APA FDR Answers To Committee Questions

B. Rebel, C. Touramanis, J. Evans

September 1-2, 2021

APA temperature sensors

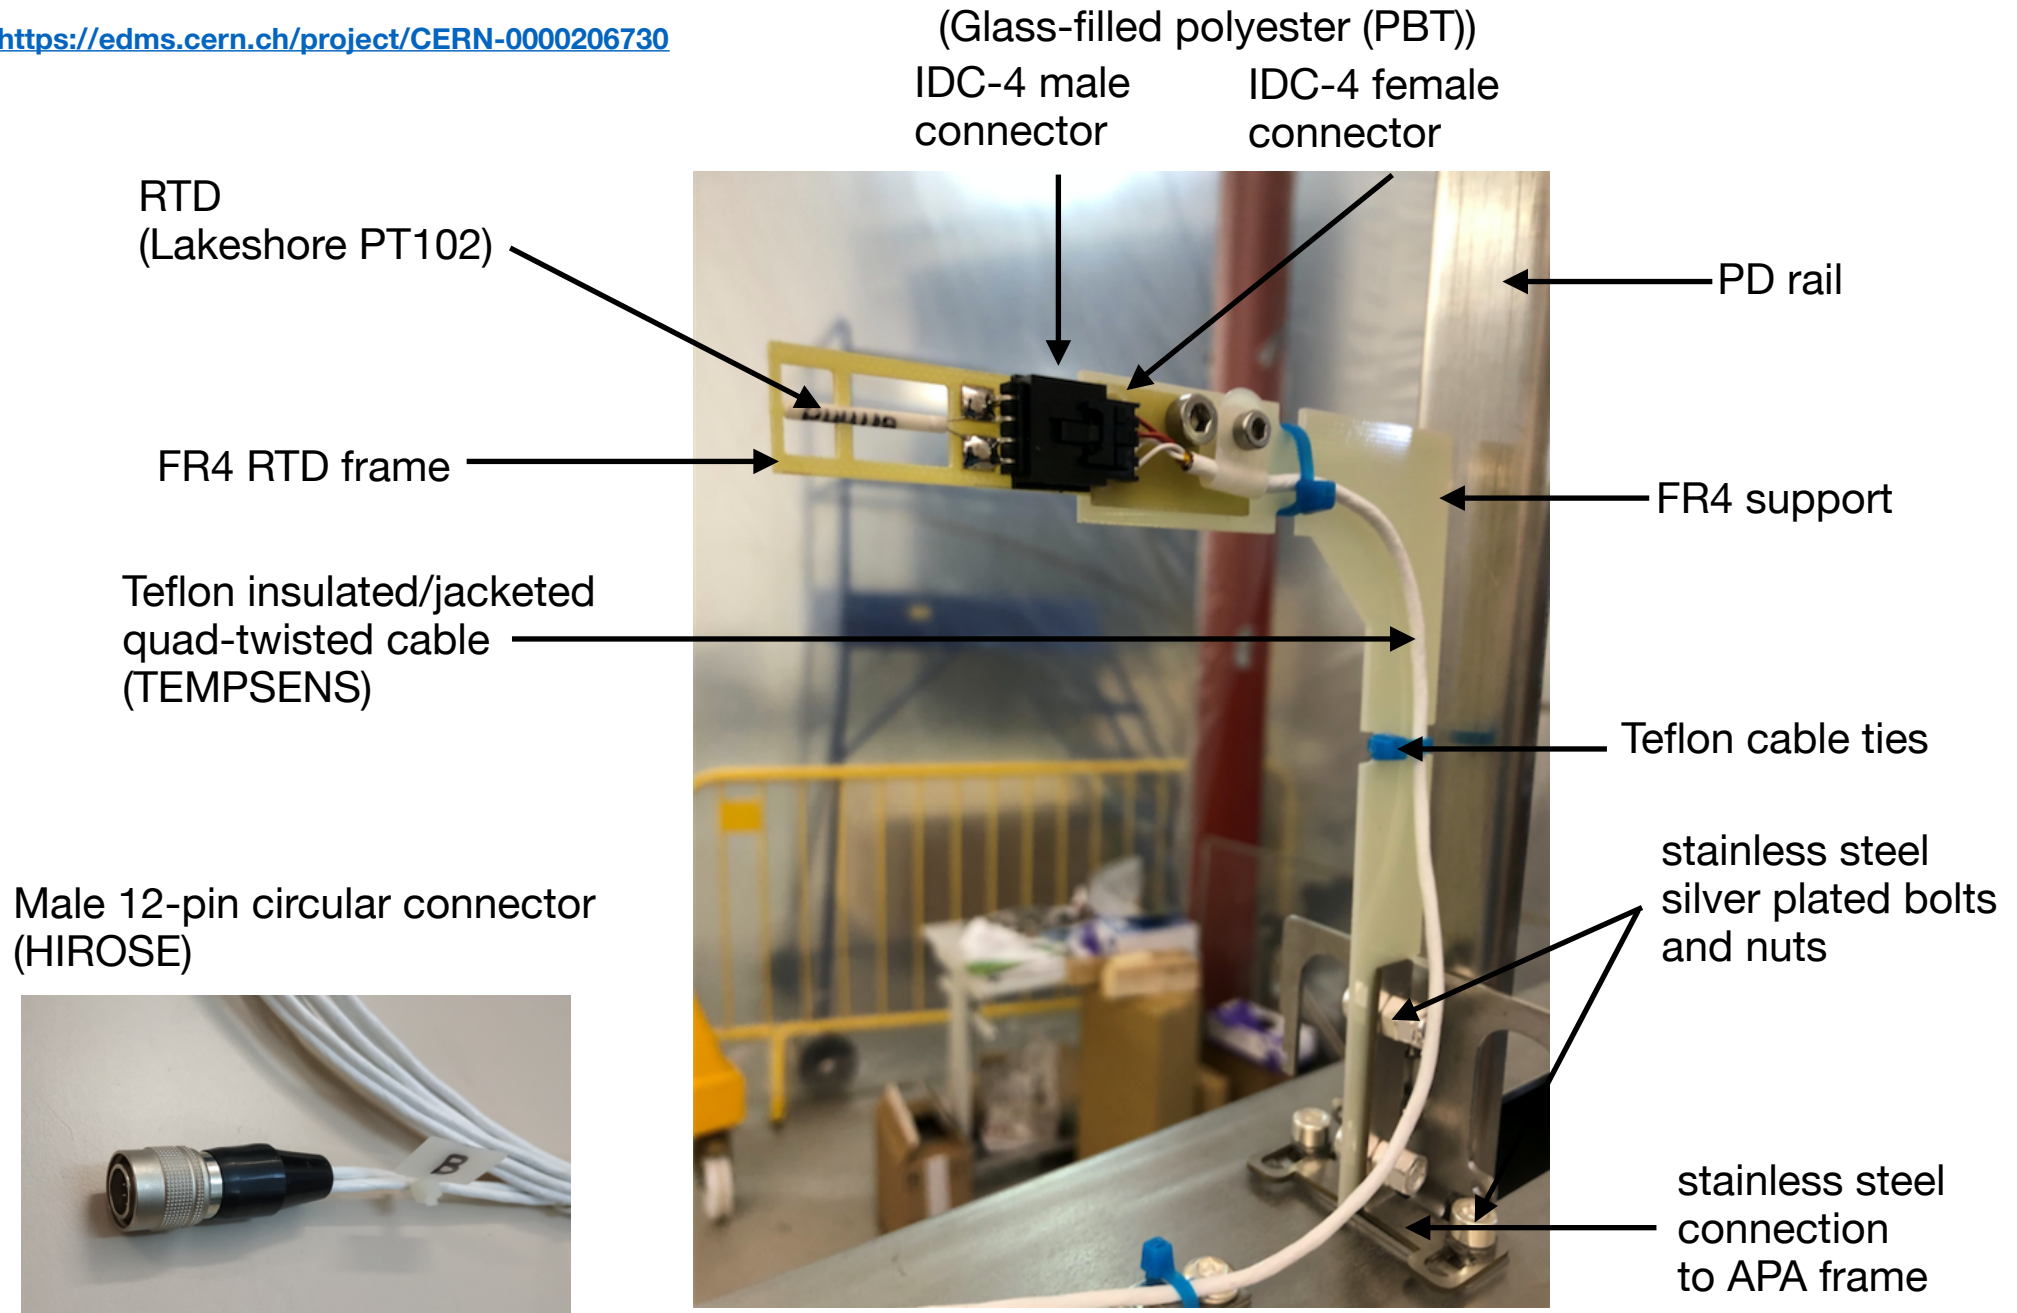
Can you please provide details for the RTD's including a bill of material, schematic, and justification for why specific things were chosen for the RTD's? (e.g. types of cables, the insulation, the connectors, etc...)

- The CALCI consortium is responsible for specifying these details of the RTDs, while the APA consortium is responsible for providing mounting points for the RTDs and real estate for the cable runs
- We agree that the concerns raised are important to address for the whole of DUNE to ensure stable operation of the detector
- ProtoDUNE experience showed that RTDs, either on the APA itself or anywhere inside the Cold Box, can introduce noise. As long as we can easily ground the whole RTD system externally we are safe.
- We contacted Anselmo Cervera to answer these questions

- Design choices:
 - Use photon detector cable routing and connectors
 - Number of sensors (4 per APA) limited by cable routing
 - Materials choice: Stainless steel, teflon and FR4
 - RTDs are decoupled from the rest (intermediate IDC-4 connectors) to allow precise calibration and avoid unnecessary manipulation during installation
 - Uninterrupted 1 mA DC current
 - quad-twisted cables with external EMC shielding individually grounded at flange and floating at sensor's end

PD module connections

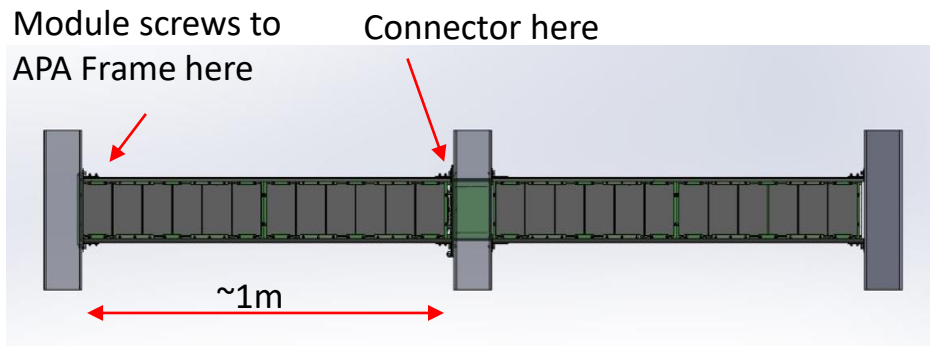
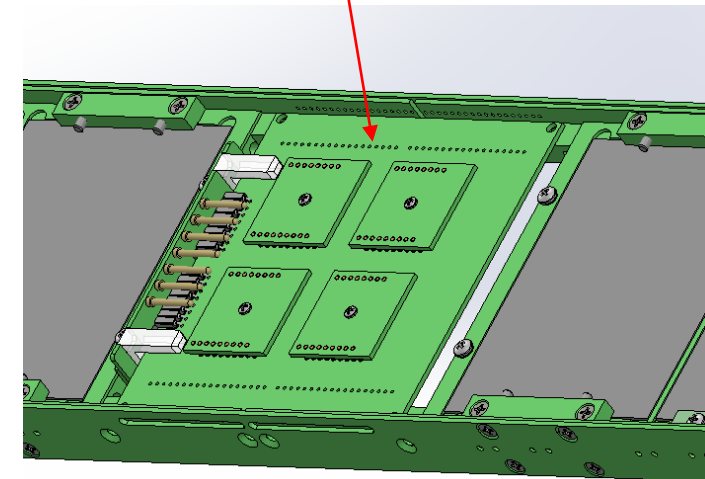
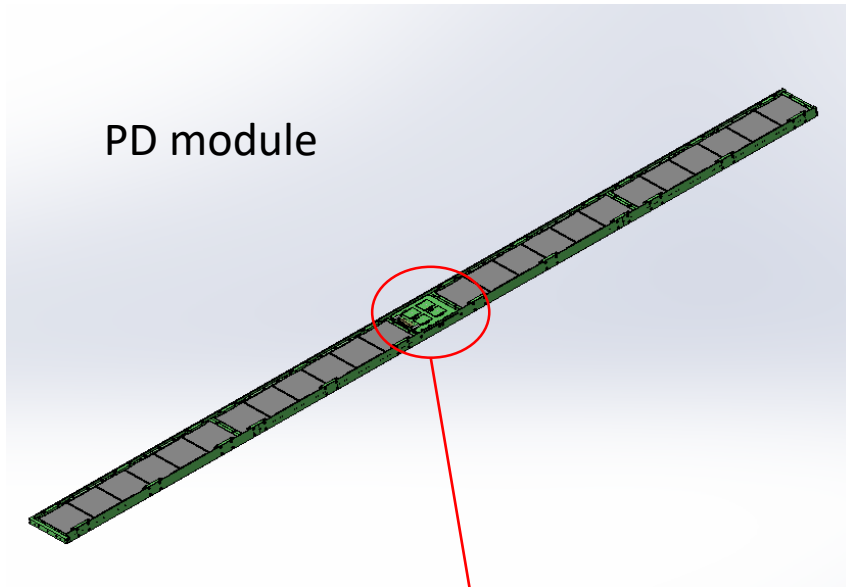
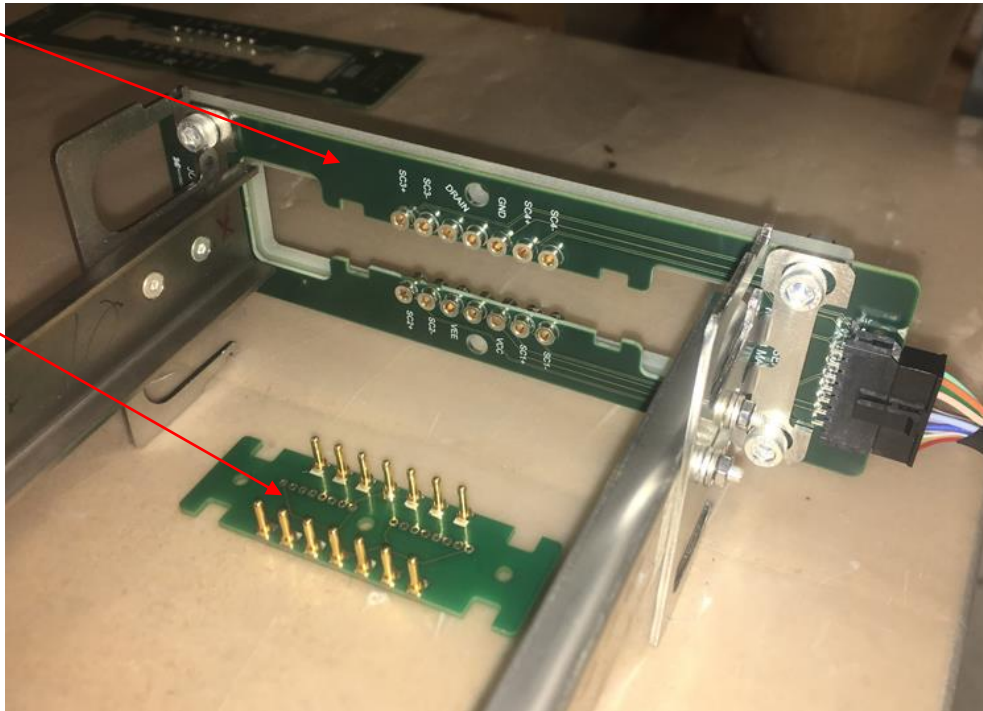
Q2: For the Photon Detectors (PD's) can you point us to documentation which shows how the PD cable is connected to the PD module, how the particular connector was chosen and how it was cold tested / stress tested?

Answer: The connection is described in general in the Photon Detector Cable Harness Rev. 6.20, which is included in the PD review documentation package. In general, mill-max pins mounted to a PCB attached to the PD module automatically mate to the sockets included in the connector board mounted to the APA during assembly. Connections went through multiple cryo tests at CSU, at PSL, and in Milano. See details in following slides.

SASEBO-D1
 (Screw and Socket Electrical Board)
 Mill-Max Pin Socket
 P/N 9837-0-15-80-14-27-10-0

AECB
 (ARAPUCA Electrical and Contact Board)
 Mill-Max Pin
 P/N 9837-0-15-80-14-27-10-0

n.b.: Relative thermal contraction of the module relative to the APA is small, but was addressed in the design.

Thermal contraction and tolerance buildup are addressed in the PD structural analysis note (Sec. 3.1) presented at the PDR (EDMS 2380229).

Board assembly during cycling

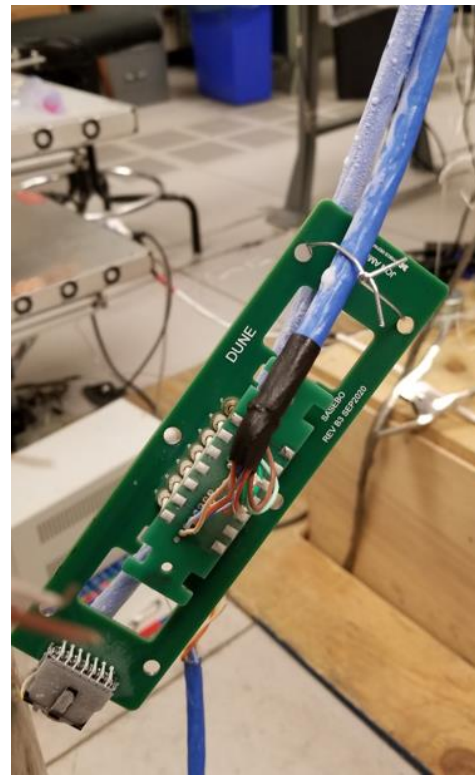
For the Photon Detectors (PD's) can you point us to documentation which shows how the PD cable is connected to the PD module, how the particular connector was chosen and how it was cold tested / stress tested?

- CSU: Multiple (>20) immersions into LN2, monitoring connectivity and high-frequency signal transmission.
- PSL: Cryogenic GN2 test of connector boards and module mockup in APA frame (2 cycles).
- Milano: Demonstrated >4 S/N ratio readout of supercell through full 35m cable harness including connector PCBs.

U-layer wires taped during soldering

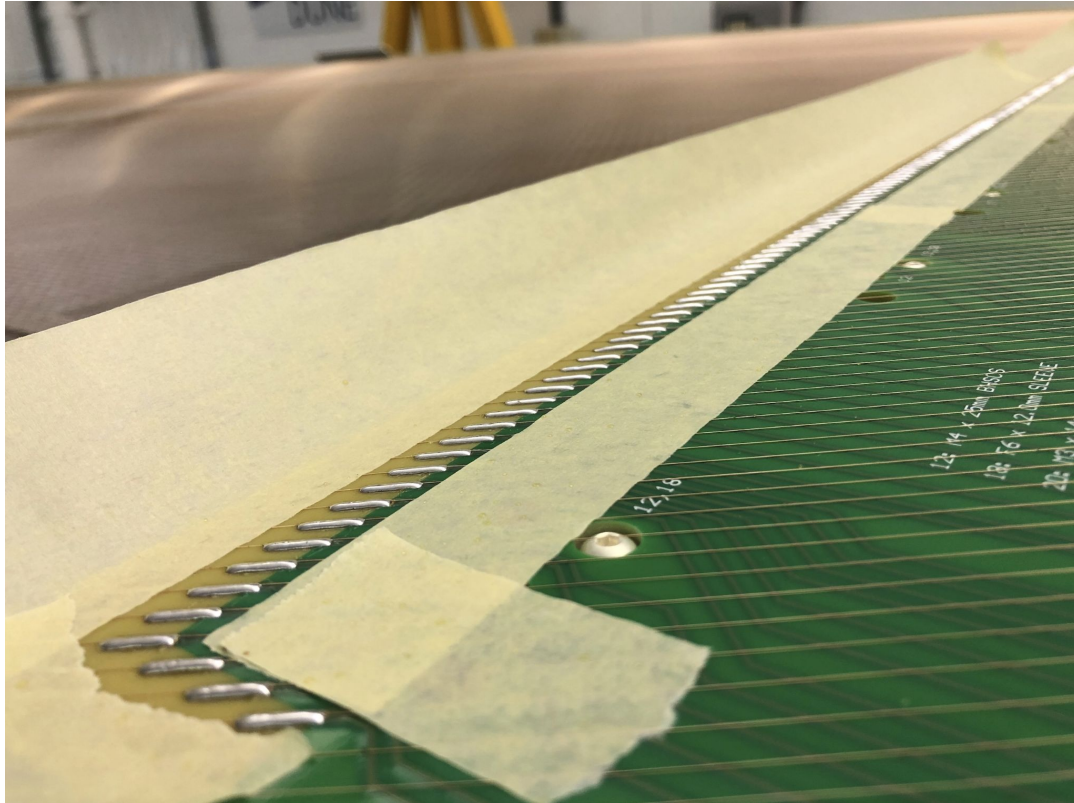
Could we receive more clarification about what is the standard practice for soldering the wires in the instance that the wires are above the geometry board? There wasn't sufficient information available from the one photo we saw to understand if the spacing that appears to be present is typical and how it is dealt with during the soldering procedure

- The [procedure for soldering the wires](#) is available on EDMS, specifically section 9.2.1 of the file 8760Doc011_Tape_Solder_Trim.pdf
- Prior to soldering the frame supports are adjusted to minimize any frame distortions that could cause wire to be above the solder pads (section 9.2.1.5)
- The wires are taped to the board before soldering, which provides a mask to prevent solder splatters on the board and also traps any ends that will eventually be cut
- Taping also holds the wire against the pad before soldering
